Subject: Duke Energy Carolinas, LLC (Duke)
McGuire Nuclear Station, Units 1 and 2
Docket Nos. 50-369 and 50-370

Application to Revise Technical Specifications Regarding Control
Room Envelope Habitability in Accordance With TSTF-448,
Revision 3, Using the Consolidated Line Item Improvement Process

Re-transmittal of License Amendment Request (LAR) dated
January 22, 2008

**MARKED PAGES OF PROPOSED TECHNICAL SPECIFICATION BASES
3.7.9 CHANGES**

SR 3.7.9.4

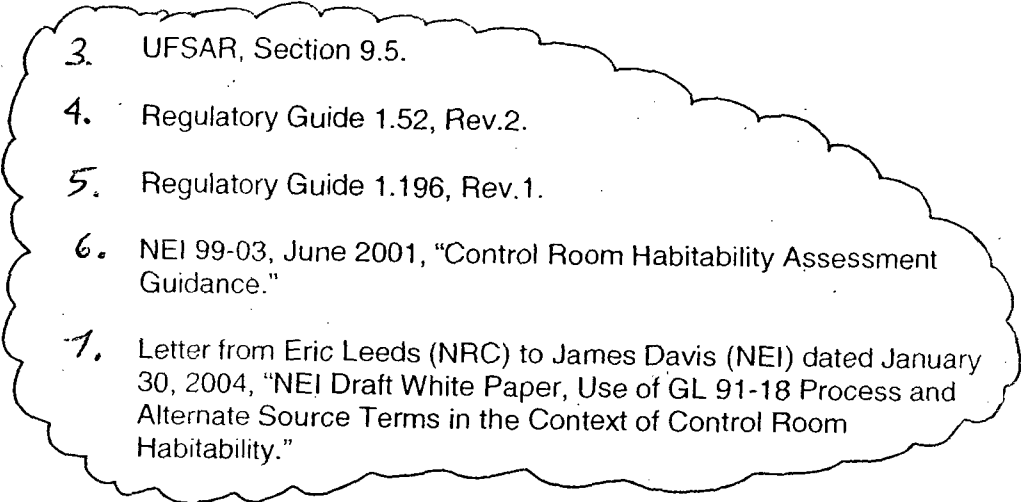
INSERT
7

This SR verifies the integrity of the control room enclosure, and the assumed inleakage rates of the potentially contaminated air. The control room positive pressure, with respect to potentially contaminated adjacent areas, is periodically tested to verify proper functioning of the CRAVS. During the emergency mode of operation, the CRAVS is designed to pressurize the control room ≥ 0.125 inches water gauge positive pressure with respect to atmospheric pressure in order to prevent unfiltered inleakage. The CRAVS is designed to maintain this positive pressure with one train at a makeup flow rate of ≤ 2200 cfm. The Frequency of 18 months on a STAGGERED TEST BASIS is consistent with the guidance provided in NUREG-0800 (Ref. 5).

INSERT 7: SR 3.7.9.4

This SR verifies the OPERABILITY of the CRE boundary by testing for unfiltered air leakage past the CRE boundary and into the CRE. The details of the testing are specified in the Control Room Envelope Habitability Program.
